14 John Street

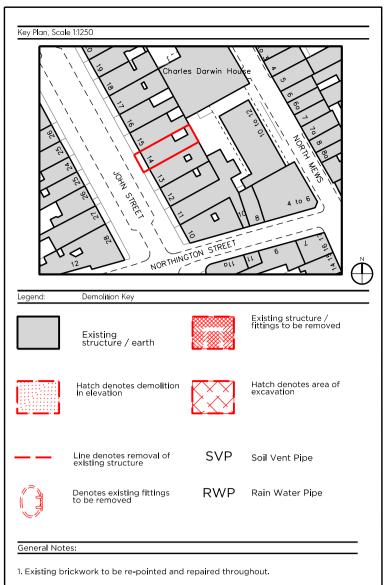
_		
01	Demolition of extension to create terrace omitted	
02	Courtyard elevation amended	
03	Notation added to confirm proposed partition	
04	Vents in roof shown	
05	Proposed airbricks shown in elevation	
06	Existing leaded lights shown in elevation	
07	Existing RWP shown on drawing	
08	Annotation added for clarification	
09	Demolition of partition for proposed door shown	
10	Powder Room moved to rear of Study
